RE: Palen Solar Power Project, Docket No. 09-AFC-7
*Palen Solar Power Project (PSPP) Supplementary Information:
Reconfigured Alternative 2 and Reconfigured Alternative 3
Technical Area: Biological Resources*

Palen Solar Power Project (PSPP)

Supplementary Information:

Reconfigured Alternative 2 and Reconfigured Alternative 3

Preliminary Site Plan Reconfigured Alternative 2

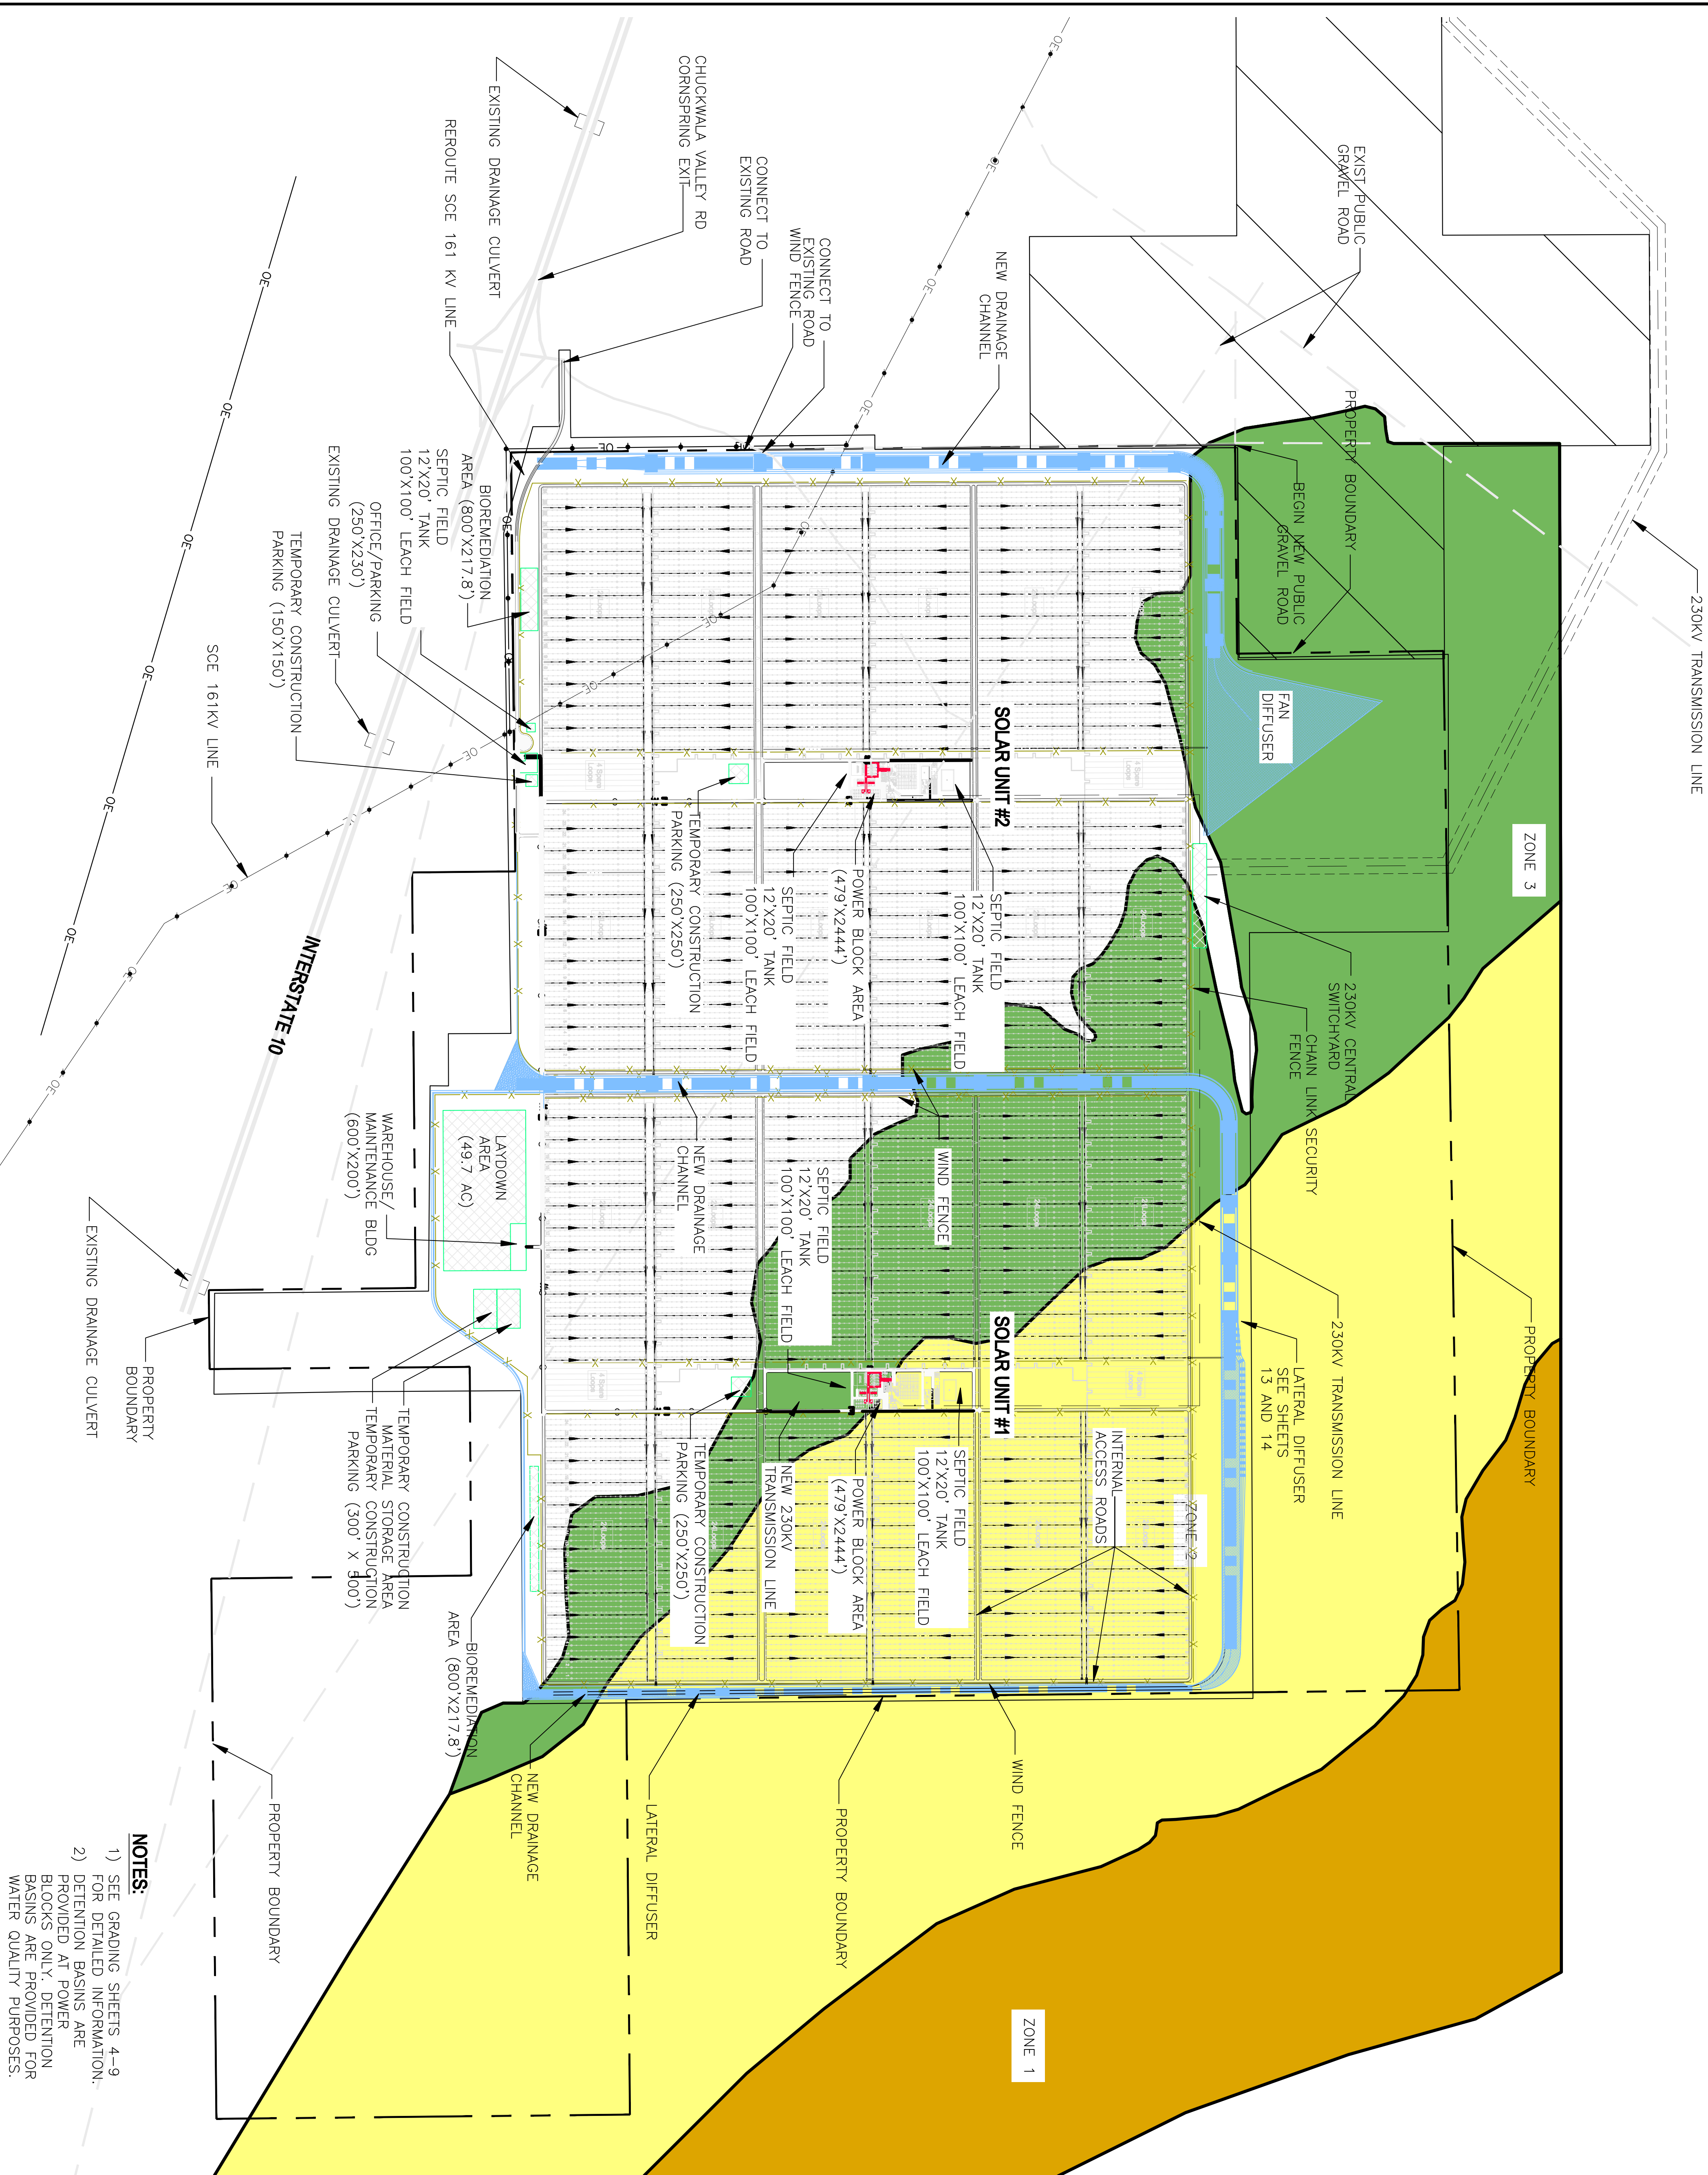
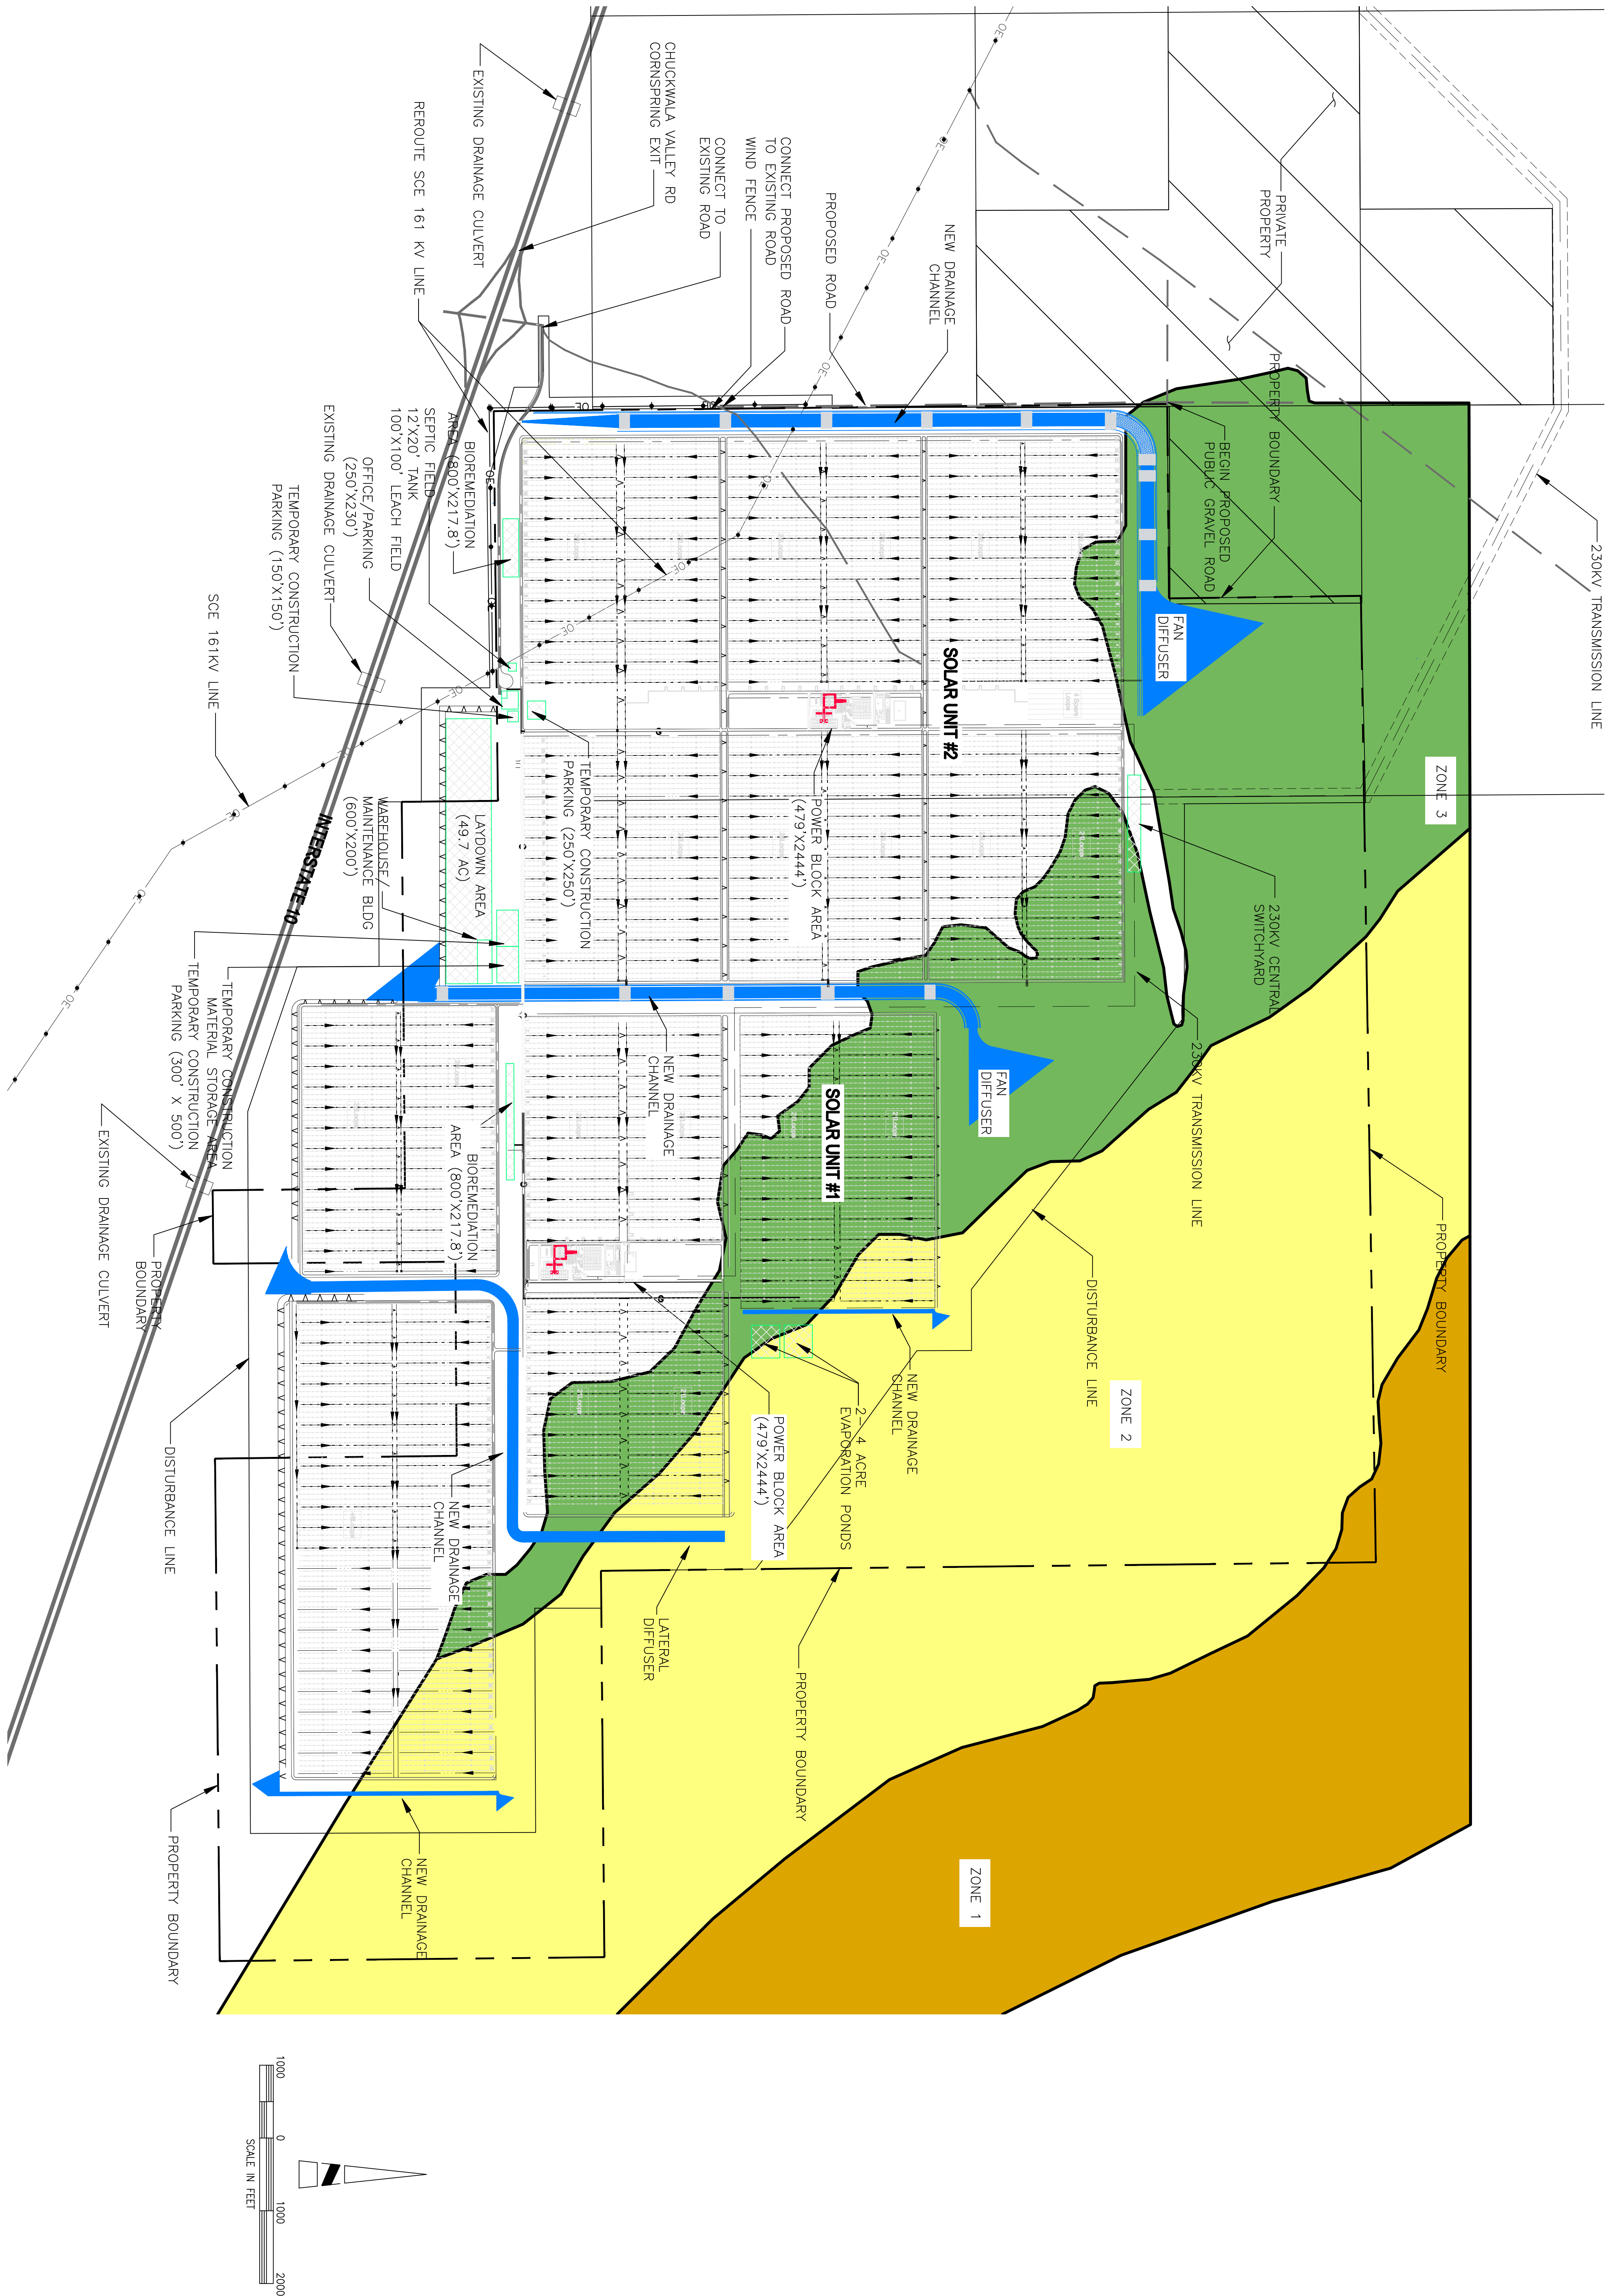
The layout of the proposed Project as described in the AFC is shown on Figure 2-1. As shown on Figure 2-2, the site plan for Reconfigured Alternative 2 has been conceptually designed to minimize the PSPP plant site footprint in Zone II of the sand transport corridor system. The Reconfigured Alternative 2 site plan generally modifies only the eastern half of the plant site for the proposed Project. As shown on Figure 2-2, the western solar field (Field 2) has remained unchanged from the proposed Project. The Reconfigured Alternative 2 solar field arrangement in the eastern field (Field 1) has been geometrically adjusted to a non-rectangular arrangement that is less than optimal from an operational perspective. However, the proposed arrangement has been evaluated and adjusted to minimize the resultant operational inefficiency. The Reconfigured Alternative 2 site plan eliminates eight solar loops, for a new total of 280 loops, and relocates 140 solar loops from the northeast portion of the proposed Project site plan to an area further south that was not previously used as part of the Project design. This new area south of the proposed Project footprint is a mixture of public land managed by BLM and two privately owned parcels not currently controlled by Applicant. The Reconfigured Alternative 2 site plan assumes that Applicant can acquire the 240 acres of private land as part of this redesign effort. This alternative also would require adjustment of the boundaries of the BLM Right-of-Way (ROW) since the alternative includes land not currently included in the proposed ROW. The overall disturbance area for Reconfigured Alternative 2 would be 4,365.3 acres

The Reconfigured Alternative 2 site plan consists of two (2) solar power plants, each with associated components of solar fields, power blocks, and bioremediation areas, as well as a switchyard and transmission lines. The Shared Facilities area includes, a warehouse/laydown yard, and an administrative office area, and a parking lot. A single circuit 230 kV transmission line originating at each power block terminates at the Central Switchyard. A single circuit 230 kV gen-tie line will connect from the Central Switchyard to SCE's proposed Red Bluff Substation. The administrative office area for the Alternative 2 site has not changed nor has the access to the overall PSPP site. The location of the warehouse/laydown yard has shifted approximately 3,000 feet to the west, but the size of the warehouse and the functional use of the space is the same as the proposed Project.

The Project's western solar field (Field 2) consists of 288 solar loops and one 250 MW power block, along with associated internal infrastructure, drainage channels, and roadway network. This solar field is entirely unchanged from the proposed Project layout. The eastern solar field, (Field 1), has been fully revised from the proposed Project and now consists of 280 solar loops, one 250 MW power block along with internal infrastructure, new drainage channels, and new maintenance roadway locations. The technology and equipment of the solar field s (solar mirrors, HTF system, and associated infrastructure), are unchanged from the proposed Project. There are no changes to the power block equipment layout associated with Field 1, but the entire power block has been shifted south by approximately 2,700 feet. The evaporation ponds for Field 1 of Reconfigured Alternative 2 are unchanged in terms of function and size, but they have also been relocated slightly south and east of their location under the proposed Project. The Field 1 bioremediation area is also unchanged in terms of function and size, but it has been relocated to the mid-southwesterly portion of the solar field.

Other Project elements that are different for Reconfigured Alternative 2 and the proposed Project are elements whose configurations are based on overall site geometry, such as internal site utilities and maintenance roads, specifics of site grading and drainage design and the boundaries of the overall disturbance area.

Although the layout of facilities is different for Reconfigured Alternative 2 than for the proposed Project, the total area occupied by solar facilities is essentially unchanged. The layout of the reconfigured alternative would likely result in a very small increase in the total length of maintenance roads and some internal utility lines, and Project fencing. However, it should be emphasized that these changes are very minor.

The grading and drainage detailed design for Reconfigured Alternative 2 will be slightly different from the proposed Project, but the drainage concept and the grading approach will be same. The drainage plan for Reconfigured Alternative 2 site includes the West Channel and the Central Channel essentially unchanged from the proposed Project. The West Channel is completely unaffected by this alternative. The Central Channel is approximately 800 feet longer than in the proposed Project Plan, but the width and depth of the channel will remain unchanged. The flow in the channel is also anticipated to be very similar to the proposed Project Proposed configuration.

The East Channel will be approximately 7,000 feet longer than for the proposed Project, but the flows from the upstream areas to the downstream areas will be maintained for peak flows and volumes just as they were in the proposed Project. Under Reconfigured Alternative 2, one additional drainage channel has been added on the southeast side of the PSPP site to intercept off-site drainage flows. This channel will be engineered in the same fashion as the other channels such that the upstream flow is directed to the same general downstream discharge area as the pre-development flow. Also, one additional on-site peripheral channel has been added in the mid-northeastern portion of the Reconfigured Alternative 2 site plan to direct on-site flows to the appropriate downstream area. These changes should not require new conditions of certification beyond those proposed in the Staff Assessment/Draft Environmental Impact Statement (SA/DEIS).

The site grading approach for Reconfigured Alternative 2 will be essentially the same as the approach of the proposed Project. The solar fields will be graded to have small drainage swales that collect water between the solar arrays, which in turn will flow to collector channels and finally to the peripheral channels. The solar fields will be graded and terraced very similarly to the proposed Project and the site will grade generally downhill from southwest to northeast. Since the existing ground slope in the Reconfigured Alternative 2 area is very similar to with the slopes in the area encompassed by the propose Project, the volume of earthwork and associated construction water use will be very similar to the proposed Project.
